SERVICE BULLETIN

REPUBLIC AVIATION CORPORATION
FARMINGDALE, LONG ISLAND, NEW YORK
SERVICE DEPARTMENT

SERVICE BULLETIN NO. 21

INSTALLATION OF PROPELLER SAFETY SPRING

Figure 1

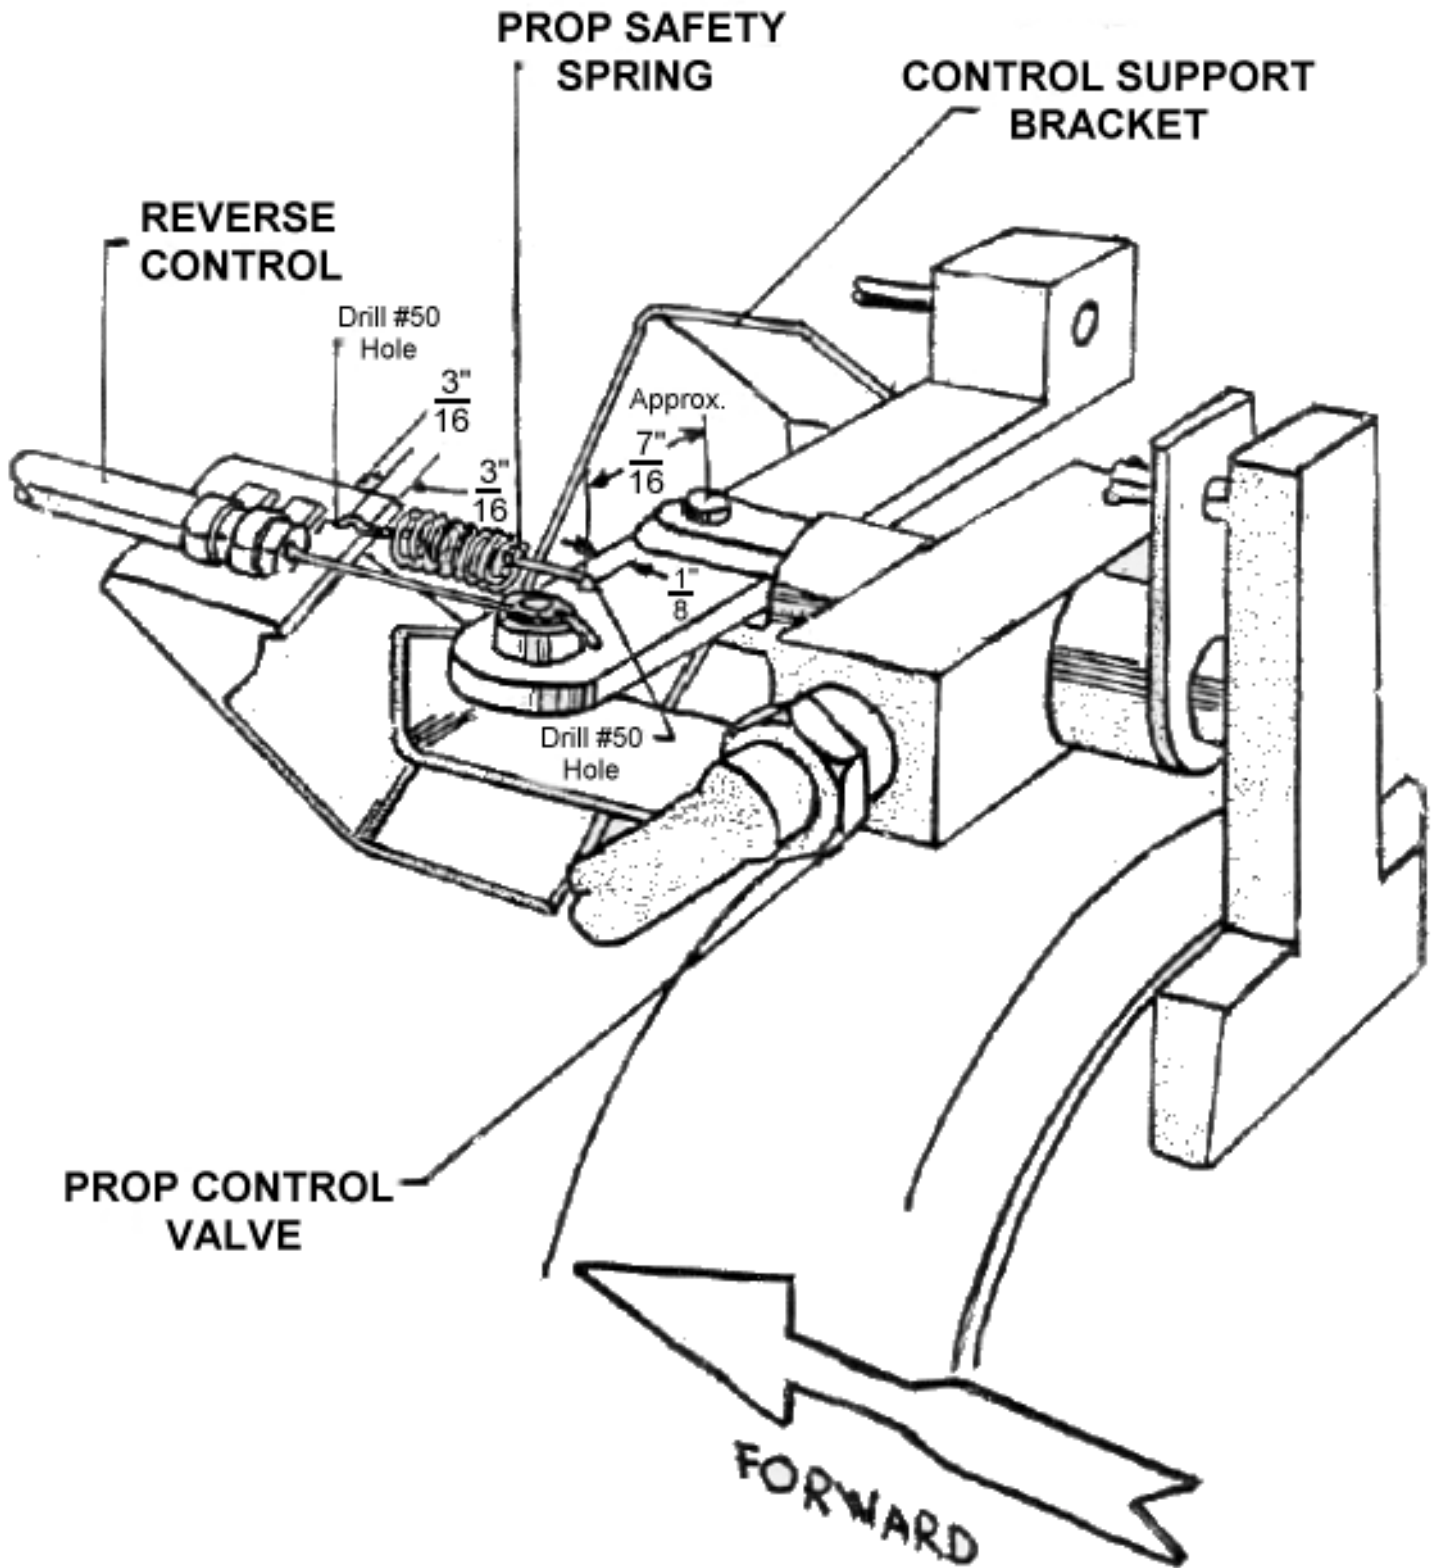
To install a safety spring to prevent the propeller from inadvertently going into reverse pitch in the event of failure of the reverse control wire (cable).

1. Unlatch and lift top engine cowl.
2. Drill hole with No. 51 drill in each of two locations shown on Figure 1.
3. Install SK-18837-1 spring.
4. Due to variations in the internal friction of the propeller control valve, it is suggested that the reverse control wire (cable) be temporarily disconnected, after the safety spring is installed and running the engine with the propeller pitch control in both high and low pitch to check the effectiveness of the safety spring in preventing the propeller from going into reverse pitch.
5. Reconnect the reverse control wire (cable).
6. Make complete ground check of propeller operating controls.
